SUBDIVISION REVIEW SHEET**CASE NO.:** C8-2017-0268.0A**ZAP DATE:** December 17, 2019**SUBDIVISION NAME:** Replat of Lot 101, Block EE of Pioneer Crossing East, Section 17.**AREA:** 1.175 acres**LOTS:** 5**APPLICANT:** Continental homes of Texas, LP**AGENT:** LJA Engineering, Inc
(Walter Hoysa)**ADDRESS OF SUBDIVISION:** 10800 ½ Sprinkle Cutoff Road**GRIDS:** MN30**COUNTY:** Travis**WATERSHED:** Walnut Creek**JURISDICTION:** Full Purpose**EXISTING ZONING:** PUD**DISTRICT:** 1**LAND USE:** Residential**SIDEWALKS:** Sidewalks will be constructed along Samsung Boulevard and Defender Trail.

DEPARTMENT COMMENTS: This request is for the replat of Lot 101, Block EE of Pioneer Crossing East, Section 17. The plat is comprised of four residential lots and one drainage/water quality lot on 1.175 acres, with a variance to LDC 25-4-171(A). This replat and associated plat vacation [Case #C8-2016-0109.3A(VAC)] is the second step in the applicant's overall plan to relocate an amenity lot and reconfigure portions of Pioneer Crossing East, Sections 16 and 17. The entire process is described below:

C8-2017-0268.0A

REPLAT OF LOT 101, BLOCK EE OF PIONEER CROSSING EAST SECTION 17

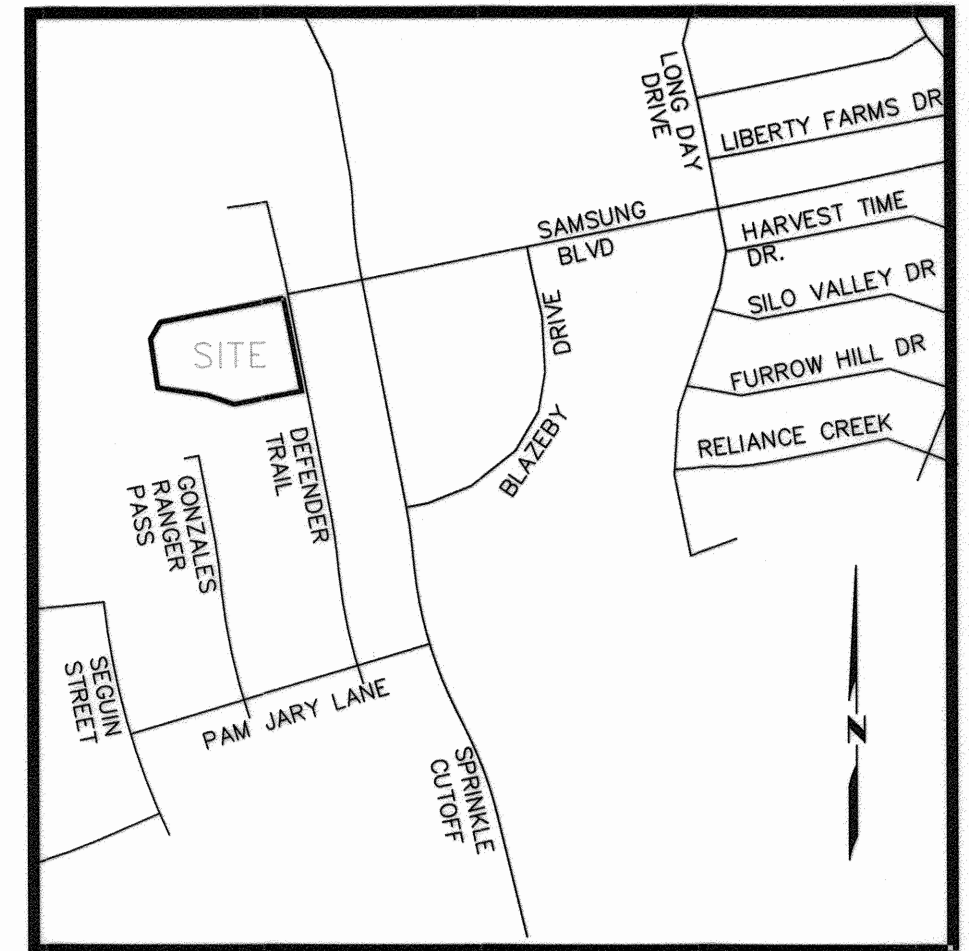
This replat requires a variance to LDC 25-4-171(A) because Lot 51 does not have frontage to a public street. This section states "Each lot in a subdivision shall abut a dedicated public street". The applicant is proposing an access easement for Lot 51. Staff recommends approval of the variance for the following reasons:

- Lot 51 is a drainage/water quality lot and is not buildable
- When Samsung Boulevard is extended, it will provide frontage to Lot 51.
- The variance will not impair orderly development of the area
- The easement is adequate to allow maintenance vehicles and emergency responders to access Lot 51.

With the variance, the proposed lots comply with PUD requirements for use, lot width and lot size.

STAFF RECOMMENDATION: The plat meets all applicable State and City of Austin Land Development Code requirements and staff recommends approval.
